Applicant: Knox & American I, LLC (Owner and Developer)

Location: 8000 Knox Avenue South, 8049 Morgan Circle and

1) Rezoning 8049 Morgan Circle, 1951 American Boulevard West, and a portion of 1901 American Boulevard West from C-5 to C-5(PD) (Amended Application – Case PL2019-40)

- 2) Preliminary Development Plans for two four-story multiplefamily residential apartment buildings (248 total units) and an existing restaurant (Amended Application – Case PL2019-40)
- 3) Final Development Plans for two four-story multiple-family residential apartment buildings totaling 248 units and an existing restaurant (Amended Application Case PL2019-40)
- 4) Variances to reduce the lot size and lot width of Lot 2, Block 1, Knox American Addition from 80,000 square feet to 78,691 square feet and from 250 feet to 191.7 feet (Case PL2019-40)
- 5) Platting Variance to defer payment of park dedication fees for Lot 2, Block 1, Knox American Addition until prior to the issuance of a building permit (Case PL2019-40)
- 6) Preliminary and Final Plat (Type III) of Knox American Addition - create three lots and four outlots (Case PL2018-255)

Figure 1 – Proposed Rezoning from C-5 to C-5(PD)

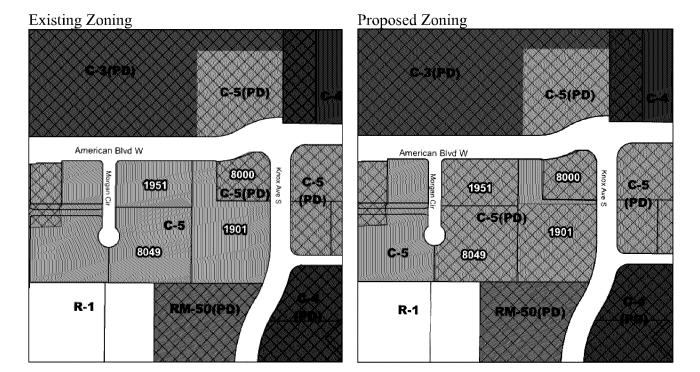
The applicants request a rezoning from C-5 to C-5(PD) to apply the Planned Development (PD) Overlay District to 1951 American Boulevard West, 8049 Morgan Circle and a portion of 1901 American Blvd. West. The request does not apply to 8000 Knox Avenue South, which is not part of the requested planned development applications and is already subject to the PD Overlay District and currently constitutes a separate planned development. The previous request for rezoning considered on November 29, 2018 (Case #PL2018-255) was recommended for approval by the Planning Commission. The Planning Commission recommendation on the rezoning request should match the recommendation on the corresponding Preliminary and Final Development Plans as they work in concert with one another. The proposed rezoning is illustrated in Figure 1. Rezoning carries a higher level of discretion than quasi-judicial actions. Although there are no explicit findings that must be made in conjunction with a rezoning, appropriate considerations include:

From a process standpoint, the rezoning approval to add the Planned Development Overlay District over the subject properties must occur prior to the approval of the Preliminary and Final Development Plans. Staff recommends approval of the requested rezoning action.
